INDEPENDENT TECHNICAL **REVIEW**

Planning Application S26/0710 **Baston Green – Land South of Deeping Road,** **Baston**

Consolidated Technical Review

Photograph 3.1: Existing highway and pedestrian environment on Greatford Road, looking East.

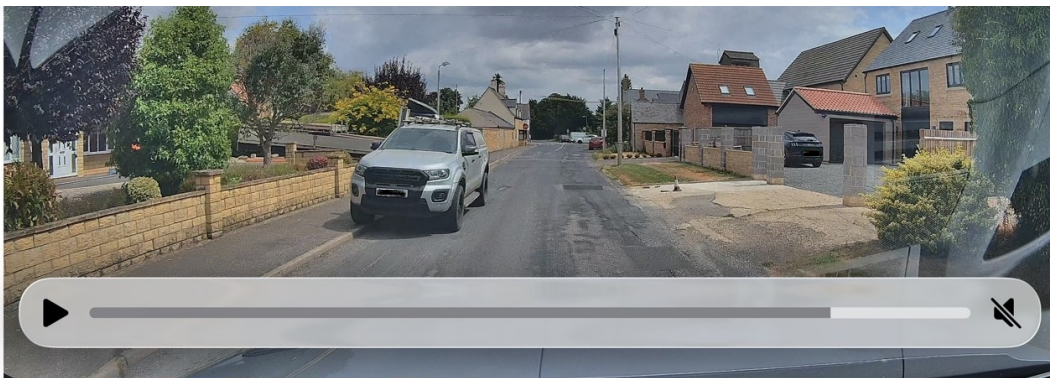
The available pedestrian route is affected in places by the relationship between the footway, residential accesses, property boundaries, parked vehicles and the carriageway.

Site observations have identified locations where the practical pedestrian environment is restricted and where pedestrians using the footway necessarily interact with vehicles entering or emerging from private accesses.

These photographs are important because they record the physical environment experienced by pedestrians rather than representing the highway solely through plan drawings or traffic-flow data.

Photograph 1 - Restricted view south towards Langtoft when turning right from Greatford Road onto the A15

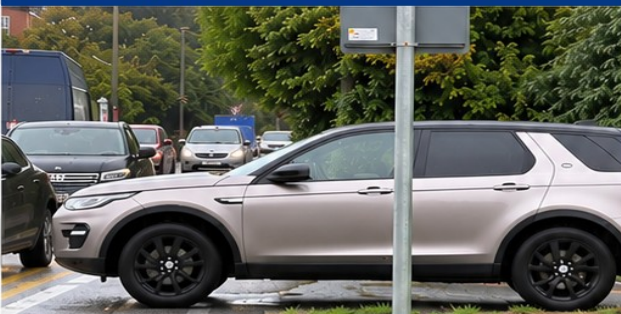
NB: Observation. *The Greatford Road/A15 junction illustrates why capacity modelling alone is insufficient. The existing visibility constraint is not caused by the proposed development, but the development may increase the frequency with which vehicles undertake the affected manoeuvre while mineral development may materially change the composition of the conflicting A15 traffic stream. The combined effect requires explicit testing.*

View from the Greatford Road junction showing restricted visibility to the south (towards Langtoft and Market Deeping) due to roadside features and passing/queued vehicles on the A15.

Photograph 2 – Pedestrians (including likely school children) from Maltby Drive crossing Greatford Road

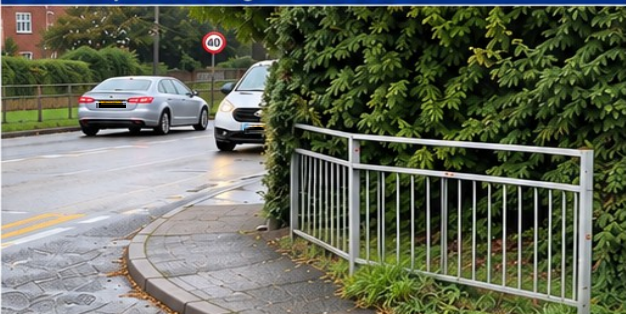
Pedestrians approaching from Maltby Drive and seeking to cross Greatford Road towards the A15 pedestrian crossing are partially screened by vegetation and are blind to vehicles heading north on the A15 and turning left into Greatford Road.
